FSSP / DMT SPP-100 / DMT CDP Processing

RAF Algorithm Review

July 25 2012

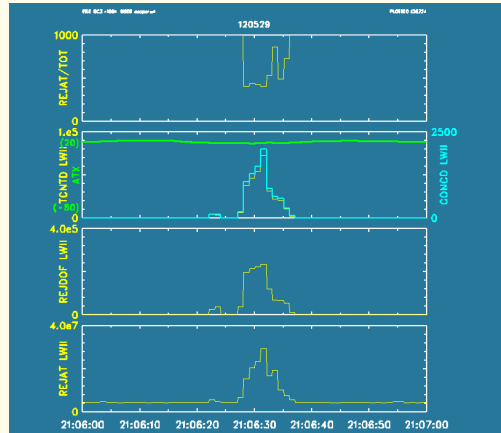
- ① Change the sums used to calculate the velocity-reject correction so that the total ranges over all available ranges, not just FIRST_BIN to LAST_BIN.
- ② Change the volume correction formula to be:

$$V'' = \frac{M}{(M + rejAT)} \frac{(M + rejAT)}{(M + rejAT + oflow)} = \frac{M}{(M + rejAT + oflow)}$$

- ③ Apply this correction prior to calling 'pms1d_rc' so that the sample volume is correctly applied to derived quantities like liquid water content.
- ④ Change variable rejAT from “xxx Average ...” to “xxx TOTAL Transit-Time-Rejected Particles”

PLOWS (2 SPP-100s, CDP)

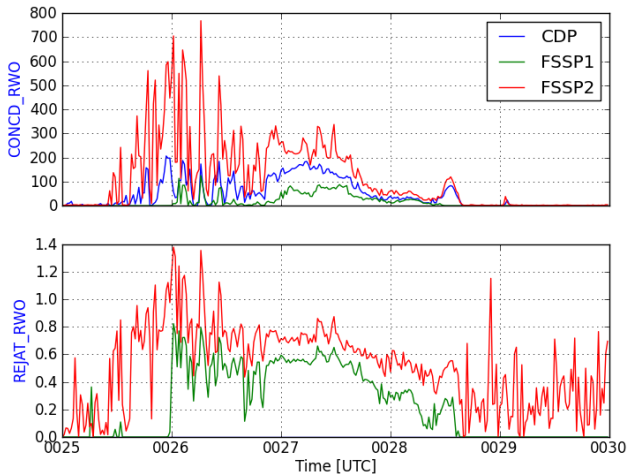
Velocity Reject Counts for the CDP

This measurement is missing for PLOWS, IDEAS-4, and HIPPO; it is present for DC3 but the values are not reasonable.
